SUNDRY NOTICES AND REPORTS ON WELLS (DO NOT USE THIS FORM FOR PROPOSALS TO DRILL OR TO DEEPEN OR PLUG BACK TO A DIFFERENT RESERVOIR. USE "APPLICATION FOR PERMIT" (FORM C-101) FOR SUCH PROPOSALS.)		WELL API NO. 30-025-29711
1. Type of Well: Oil Well ☐ Gas Well ☐ Other Water Disposal		5. Indicate Type of Lease STATE ☒ FEE ☐
2. Name of Operator COBALT OPERATING, LLC		6. State Oil & Gas Lease No. EO-8563-0004
3. Address of Operator PO BOX 519, TUSCOLA, TX 79562		7. Lease Name or Unit Agreement Name CONSOLIDATED STATE
4. Well Location Unit Letter C : 660 feet from the north line and 2128 feet from the west line Section 9 Township 17S Range 37E NMPM LEA County		8. Well Number 003
11. Elevation (Show whether DR, RKB, RT, GR, etc.) 3778 GR		9. OGRID Number 286255
		10. Pool name or Wildcat MIDWAY STRAWN

Plugging Plan
Cobalt Operating, LLC
Consolidated State 003
API 30-025-29711

Operator: COBALT OPERATING, LLC PO Box 519 Tuscola, TX 79562	OGRID: 286255
	Action Number: 312677
	Action Type: [C-103] NOI Plug & Abandon (C-103F)

**BEFORE
 PLUGGING**

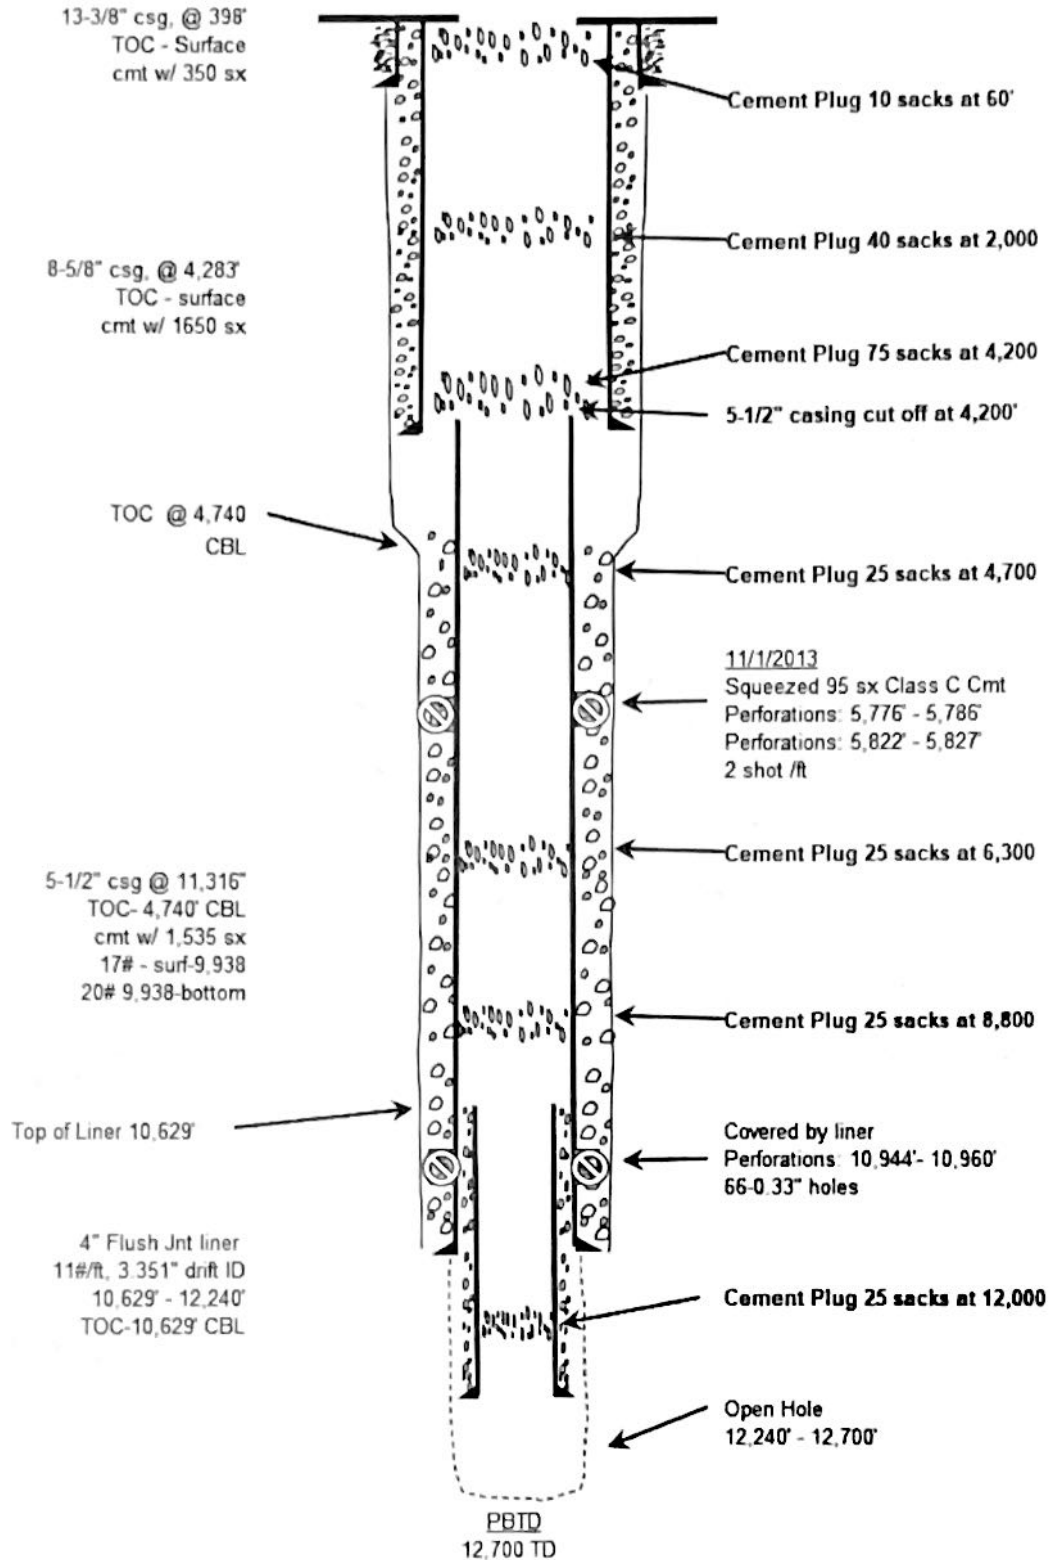
See Changes to plugging plan

1. MIRU, Unset packer and POOH with 2-3/8 and 2-7/8 tubing and packer.
2. Run in hole with tubing to 12,000, circulate 9.5 ppg salt mud to surface.
3. Set CIBP @ 12200' - test casing and plug 500psi/30min

4. Spot a 25 sack Cl H cement plug at 12,000-11,600. - WOC & Tag
5. Spot 15 sx Cl H cement 11366' - casing shoe
6. Spot 40 sx Cl H cement 11010' - 10580' - Old perforations- TOL

7. Spot a 40 sack cement plug from 8800 to 8450'. - T Wolfcamp & Abo
8. Spot 10 sx Cl H cement 7760' - 7660' - T Tubb
9. Spot a 25 sack cement plug from 6300 to 6119'

10. Spot 20 sx Cl C cement 5880' - 5720' - Old perforations
11. Spot a 25 sack cement plug from 4,925' to 4,719. POOH with tubing.
12. Nipple down wellhead, cut 5-1/2" casing at 4,200' lay down 5-1/2" casing.

13. Run CBL to surface to verify bond. - Perforate as needed
14. RIH with tubing to 4250' and spot 85 sack Class C cement plug at 4250' to 3988', tag this plug

15. Spot 35 sx Cl C cement 3222' - 3122' - T Yates
16. Spot a 40 sack cement plug at 2000 to 1887'
17. Spot 35 sx Cl C cement 675' - 575' - T Salt
18. Spot a 70 sack cement plug at 200' to surface

19. Rig down plugging equipment. verify cement to surface on all casings
20. Cut off casing and cap with steel plate and dry hole marker. Clean and reclaim location.
